**Report: ISSUES**

**Function: Test, Adjust, & Balance**

**08-25-25 CHIPOTLE #5270 LOUISVILLE, KY  
(PRESTON CENTER)**

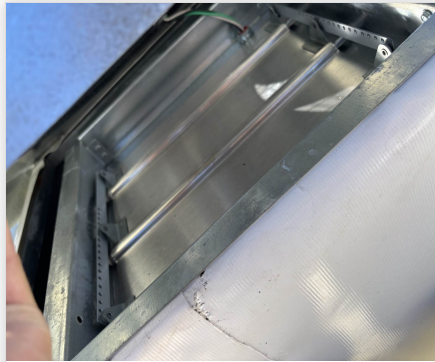
**Issue Name :** MUA ORIENTATION  
**Description :** MUA orientation shows the outside air intake is close to the exhaust fan.  
**Created By :** National TAB                      **Assigned To :** National TAB - Dan Hertenstein  
**Status :** Closed  
**Priority :** Urgent                                      **Asset Tag :**  
**Originated Date :** 08/28/2025 - Cavin Van - National TAB
